31/6-98E 10211 Armory Avenue
(Kensington Historic District)

HISTORIC PRESERVATION COMMISSION STAFF REPORT

PROPOSAL: Porch alteration, window replacement

Porch Renovation
(10211 Connecticut Avenue)
10211 Armory Avenue

Proposed Porch
10211 Armoncy Ave

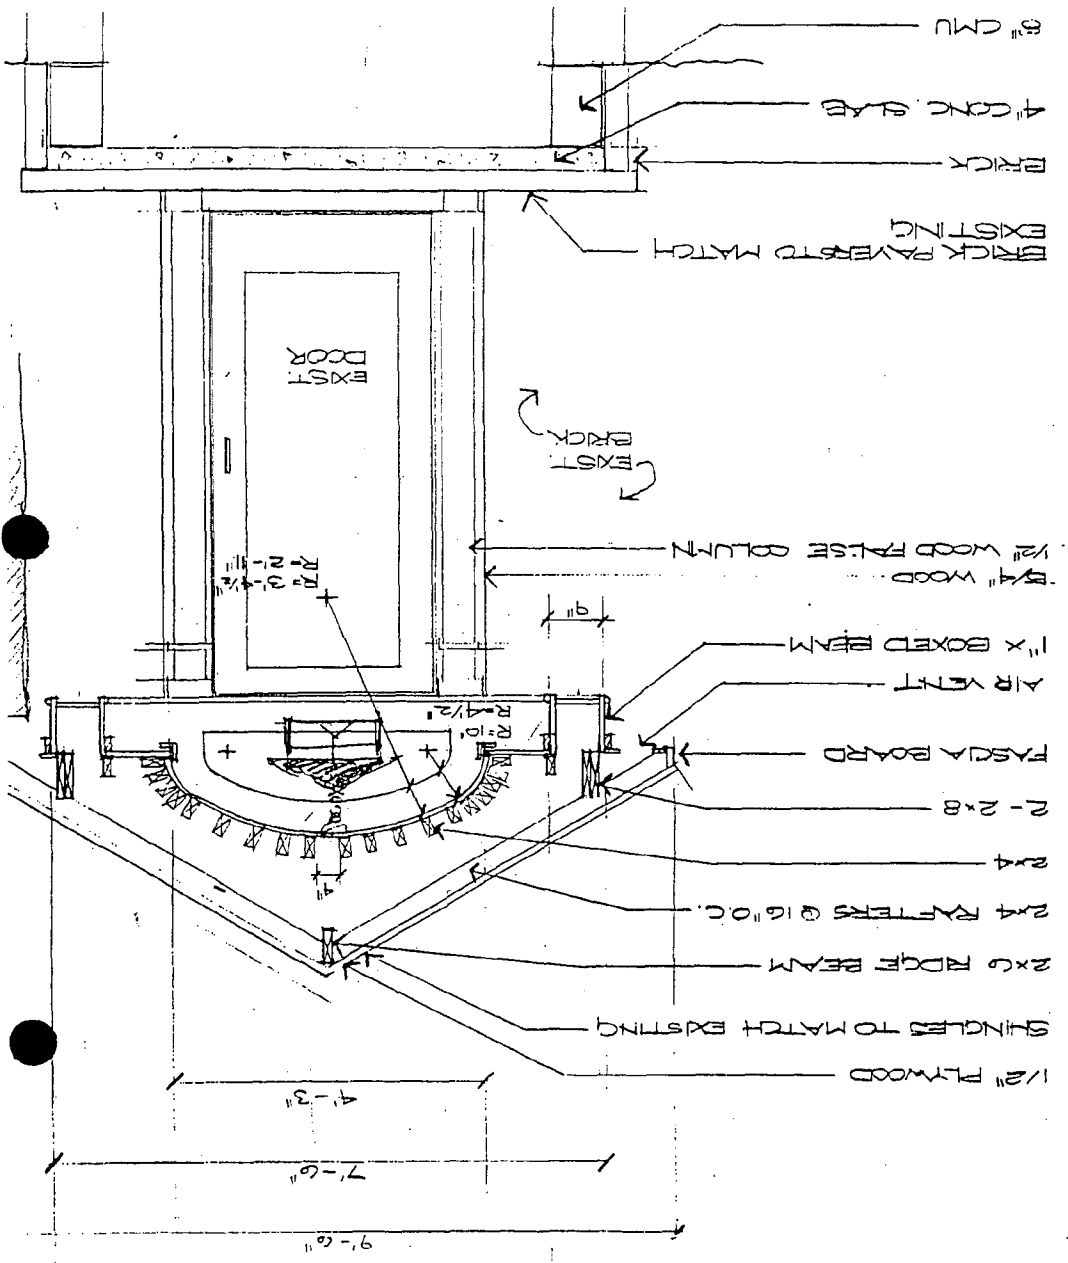
{PREVIOUS SUBMISSION}

Scale of porch columns + roof connection
Column is too small for steps plinths +
capitals.
To reduce the scale of the front porch -
this is wider than the existing stoop.
- Cleaner lines - more Federal Revival style. Square lines.
Smaller -
- Bring back to one style.
= Seeing this drawing on the house.

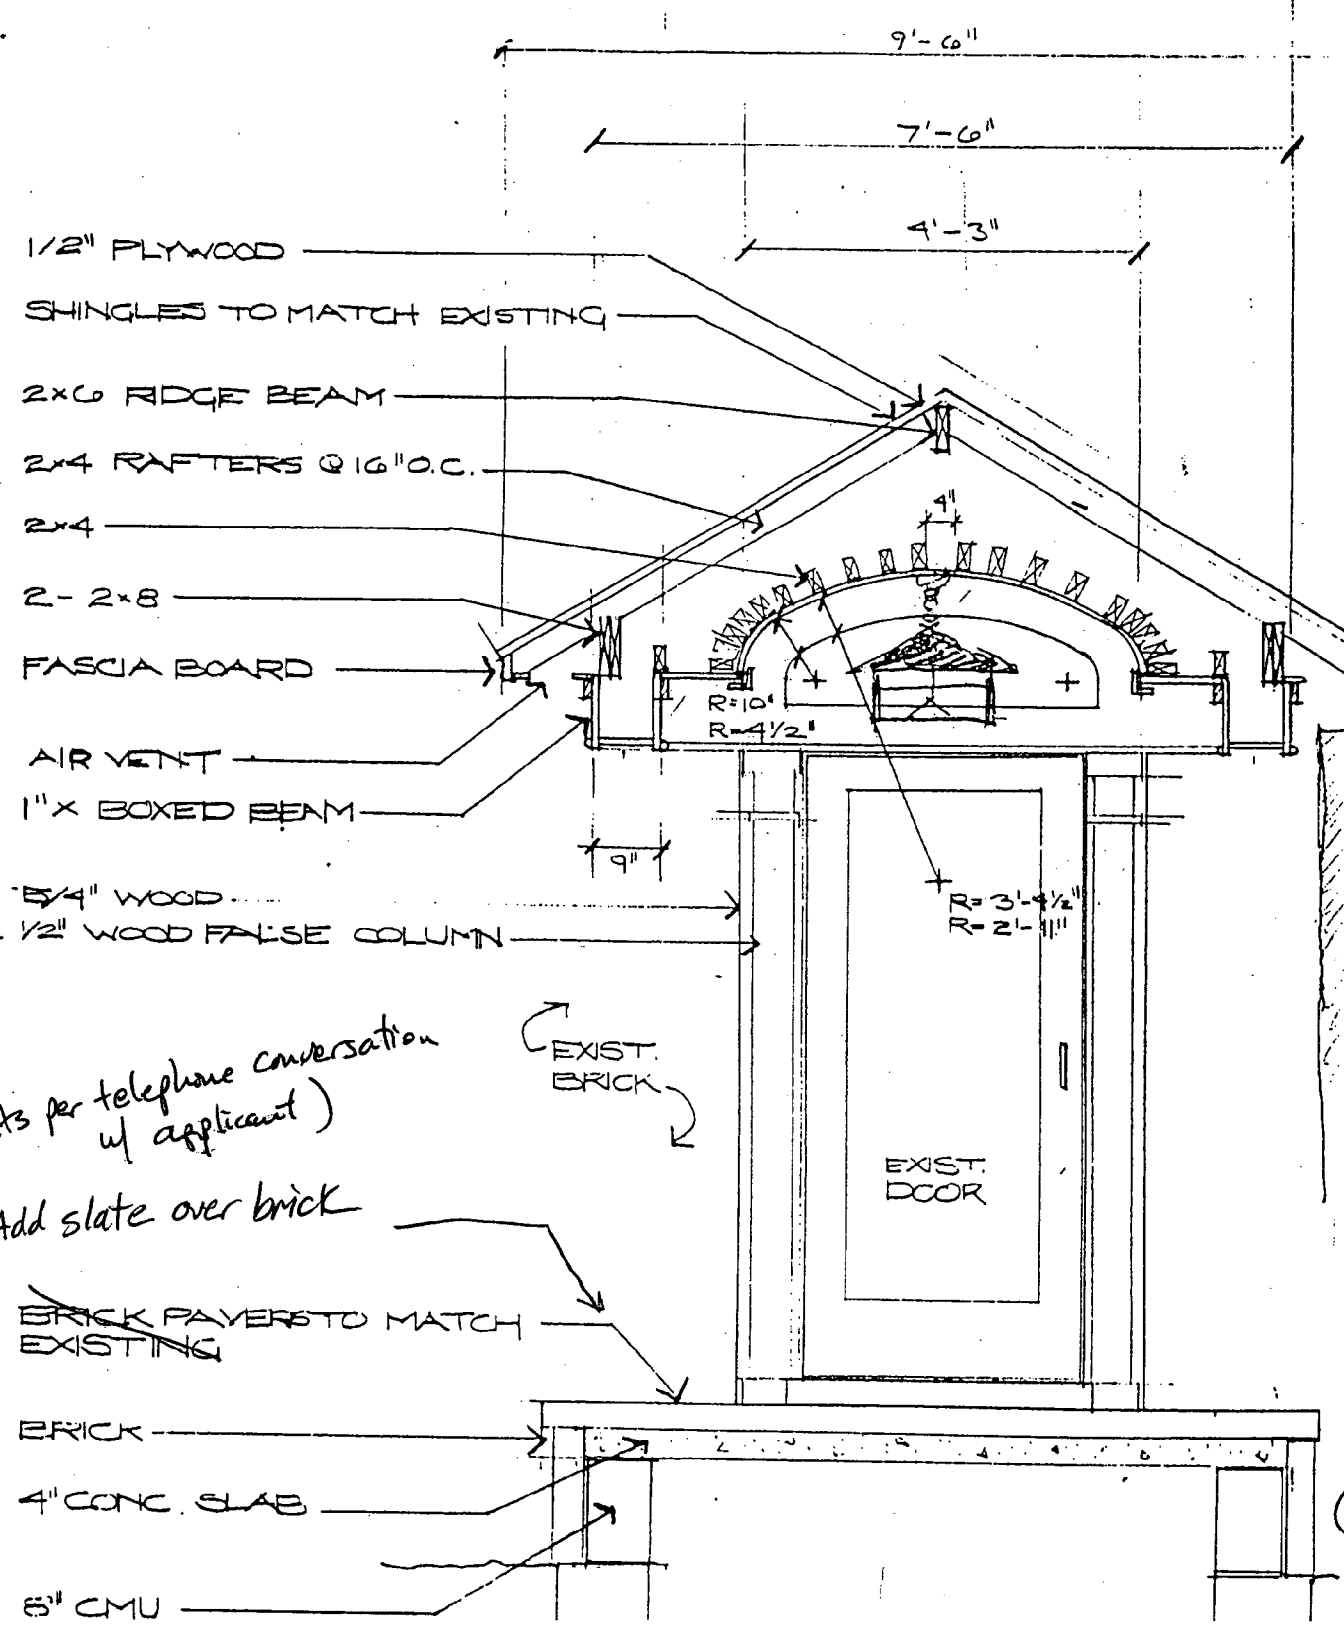
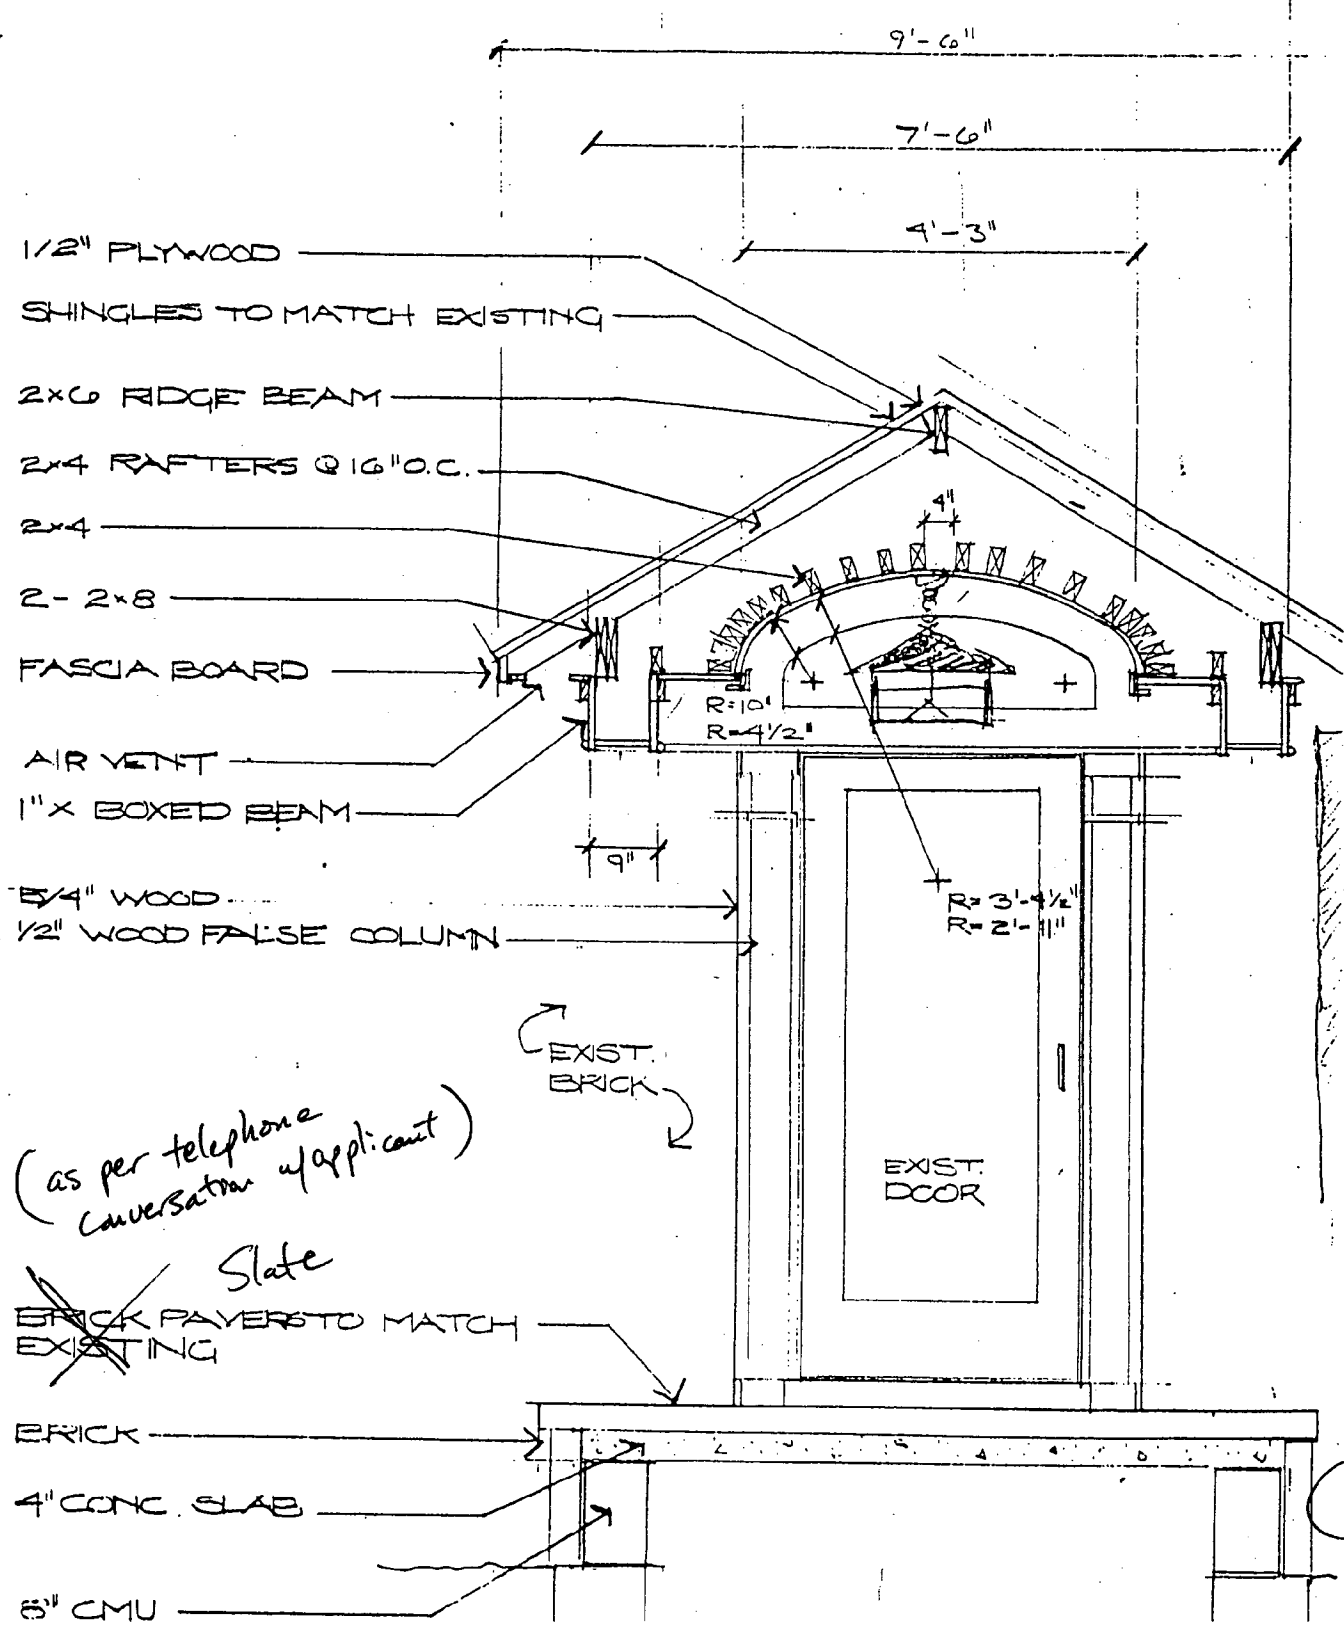
(As per telephone conversation
of applicant)

Add slate over brick

~~BRICK PAVEMENT TO MATCH
EXISTING~~
